Traffic Assessment Statement: Date:10/03/2023 Ref:P/2023/0008

Site Address: The Former Co-Op, Well Street, Cefn Mawr, Wrexham, Change of use from A1 (Retail) to Class B1 (Business) and B8 (Storage & Distribution)

From:	Chief Officer, Environment & Technical	To:	Chief Officer Planning & Regulatory
		FAO:	Sharon Holman
Our Ref:	ET/DC/MM/P/2023/0008	Your Ref:	P/2023/0008
Date:	8 th March 2023

The Cooperative, Well Street, Cefn Mawr, Wrexham
Change of Use of Building from Class A1 (Retail) to Class B1 (Business) and B8 (Storage & Distribution)

The proposed change of use relates to the existing building at circa 800m² and ancillary parking area. See Appendix 2 marked – 'location plan'.

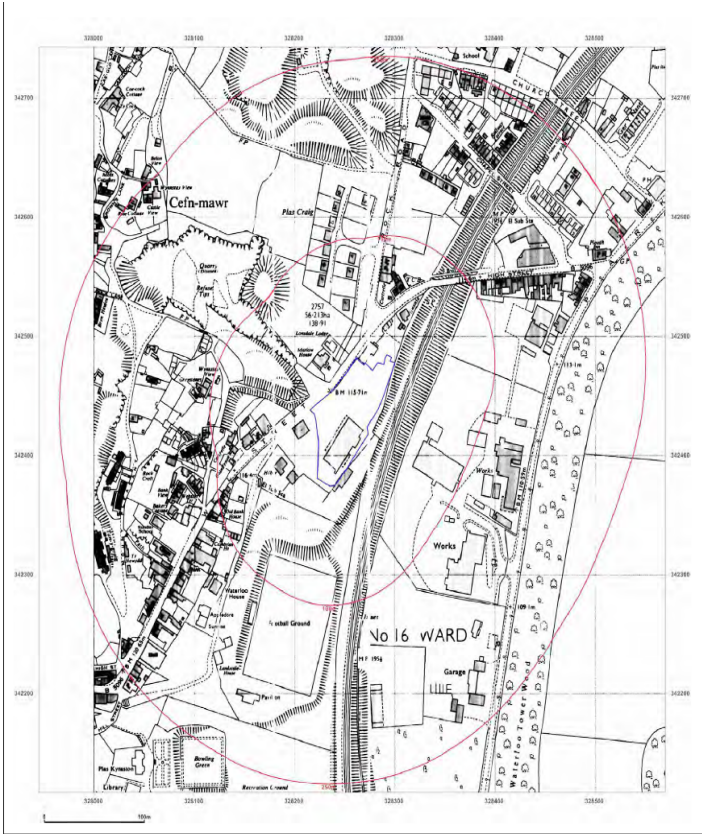
The Design and Access Statement has been reviewed however it is noted that the information provided in the Design and Access Statement and associated drawings is limited.

The proposal uses the existing vehicular access from Well Street. Further information should be provided to show any improvements proposed for the existing site access.

Swept path analysis should be provided for the access junction and site manoeuvres, using the largest vehicle that is expected to access the site.

Visibility splays should also be provided and should comply with TAN18.

The applicant has expressed that they do not intend to alter or improve the existing access (save for maintenance reduction of existing shrubs). Also, the addition of a dropped kerb to the main pedestrian access across the entrance of the site, with improved markings to denote the access. The access will broadly remain unchanged as utilised since circa 1962 or 70 years – save for the dropped kerb and markings. If deemed necessary, a condition for improved access by way of a dropped kerb can be imposed in agreement with the applicant.

The visibility splays will remain as existing with a note that the adjacent access onto Well Street has a speed restriction of 20mph (easterly and westerly), with reduced speeds of vehicles leaving the ring junction or roundabout - easterly. It is also noted that the parking restrictions (double yellow lines) reduce the possibility for stationary obstacles impacting visibility.

The existing use class allows for the access of HGV vehicles without restriction - day/night or frequency are unconditioned at present. From initial enquiries and market analysis, the site will be predominantly B8 (storage.) It will be accessed by small LGV rigid vehicles and the largest expected is lorry-mounted crane vehicles. The applicant accepts that this could indeed be conditioned within the permission (i.e. restriction of larger vehicles accessing the site). Therefore, reducing the size of vehicles and with the Chief Officers' agreement, negating the requirement to provide both a visibility splay analysis and or swept path analysis. This will aid in the financial viability as expressed above and bring the redundant site back to use whilst considering highway safety.
